**ROCKY FLATS ENVIRONMENTAL
TECHNOLOGY SITE**

**771 Closure Project
Decommissioning Operations Plan
Modification 5**

August 8, 2003

Figure 4. Building 771 First Floor Plan Demolition Concept

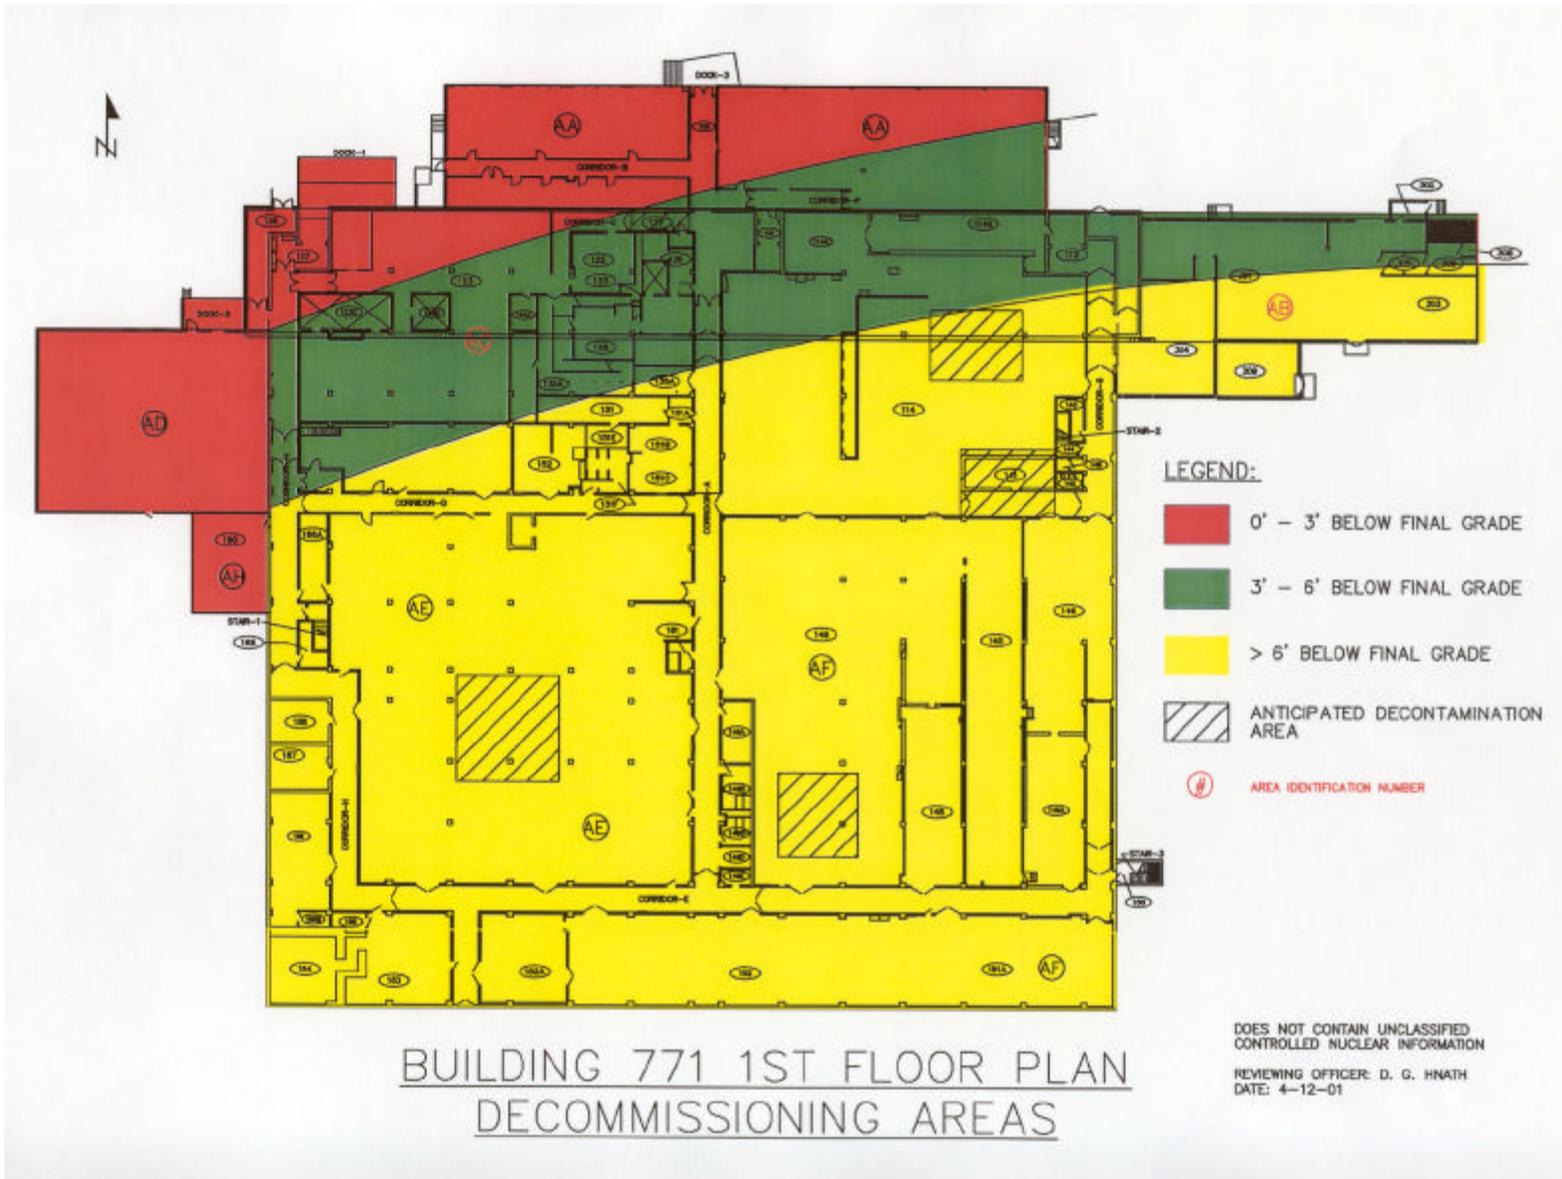
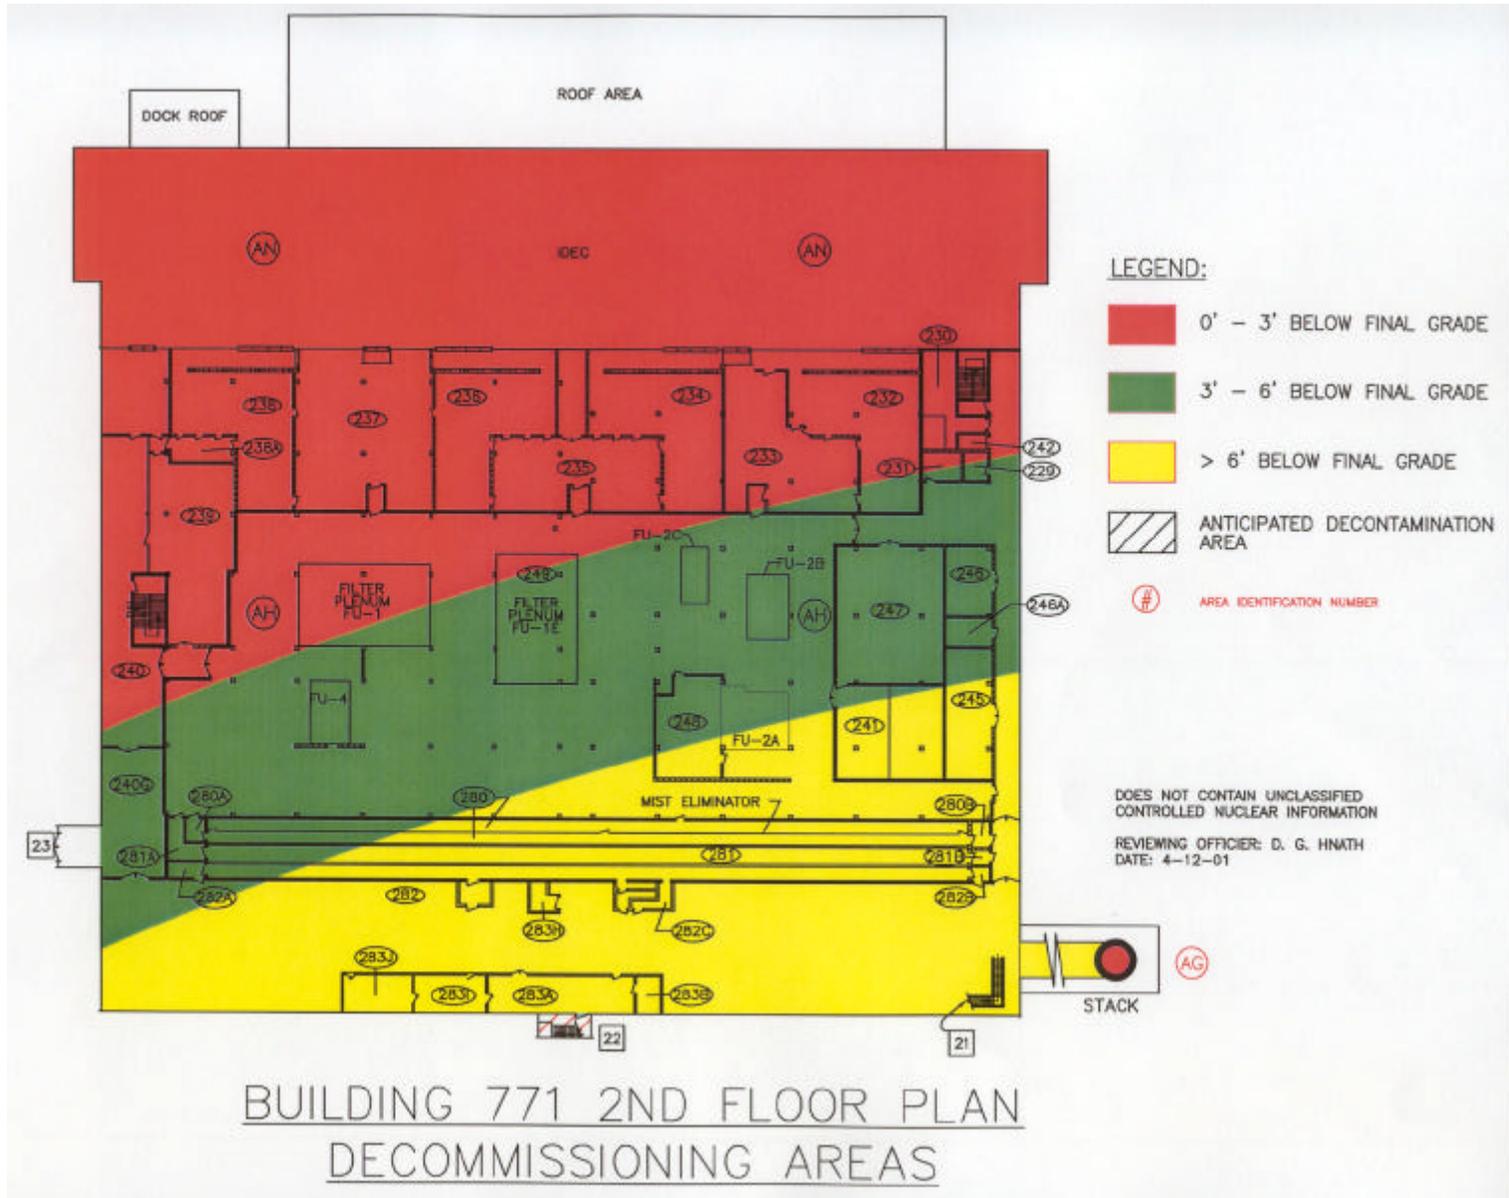
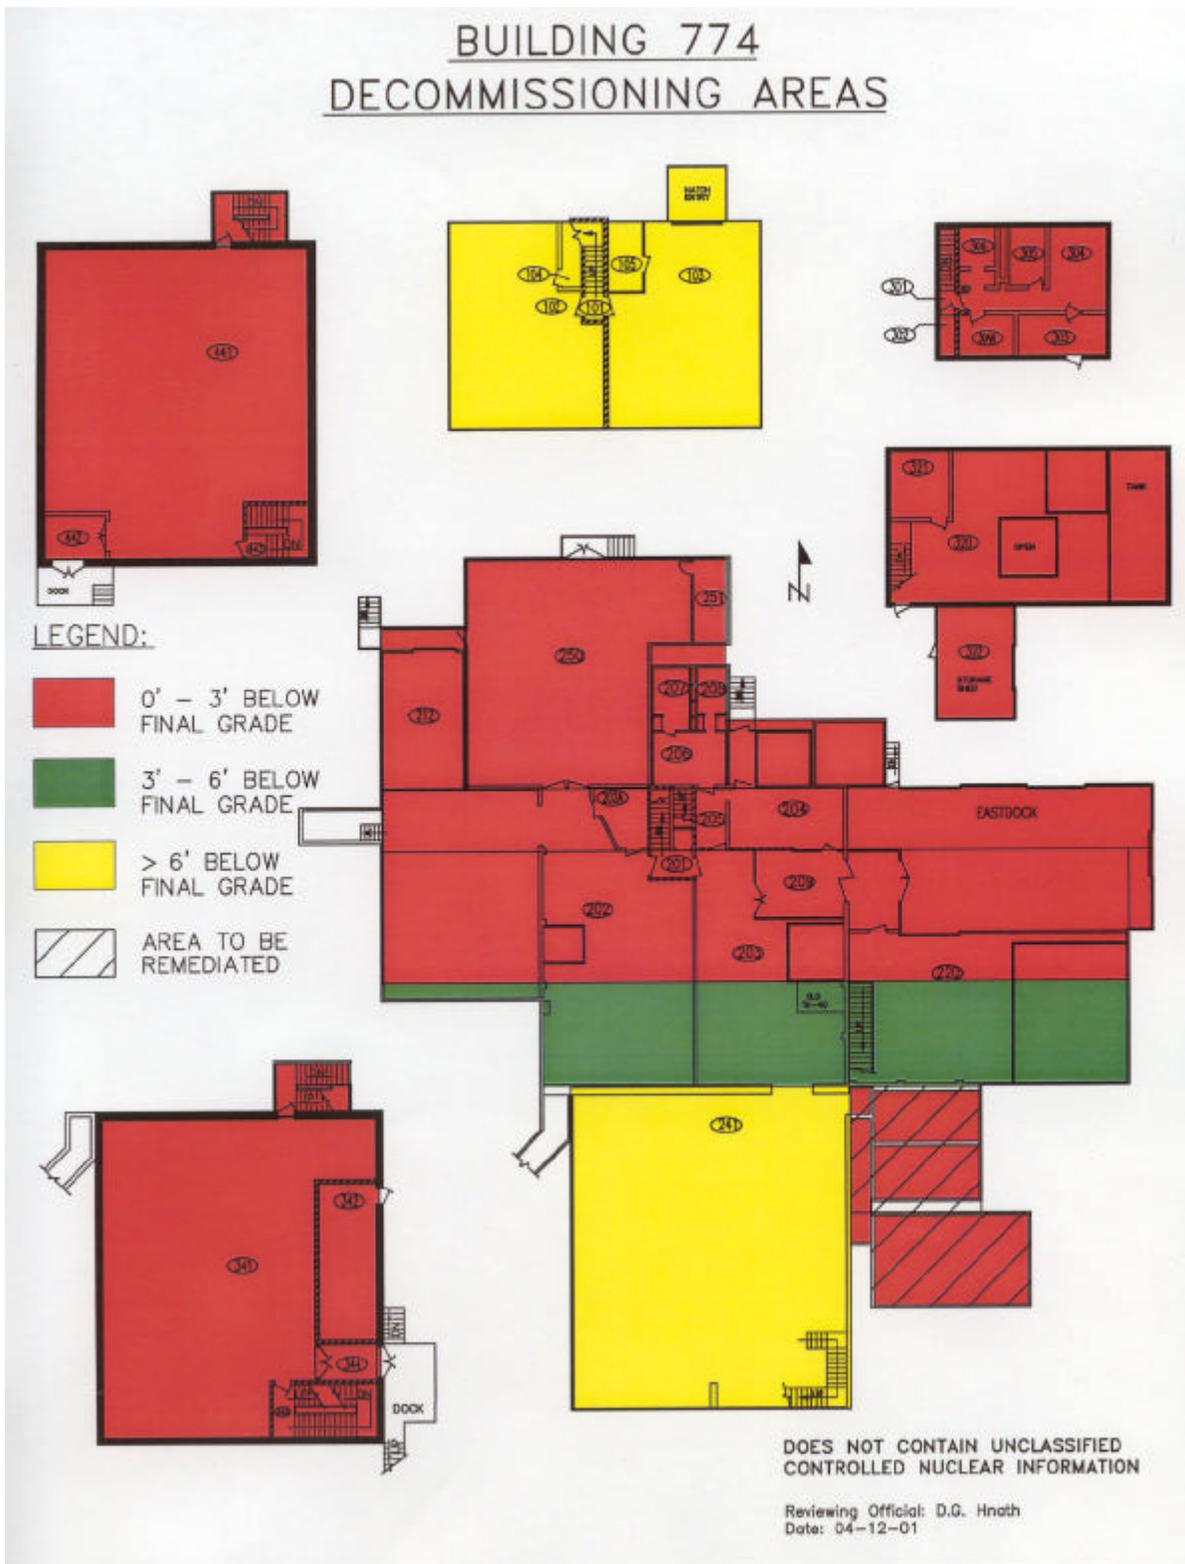
5	<p>Figures The text in Section 4.7.1.8 (Demolition of the Main Building 771 Structure) describes the planned three-sided configuration for the Building 771 foundation area after demolition, and states that "Figures 4 and 5 provide an aerial view of this concept." Figures 4 and 5 provide a useful aerial view, but they do not show the three-sided configuration referenced. During the Coalition staff briefings, Site representatives distributed side-view diagrams of the post-demolition condition of B771 and B774. It would be helpful to include these diagrams so that the reader has a better understanding of the depth of the buildings and how much of the structures will be demolished.</p>	<p>These figures were added to the document.</p>
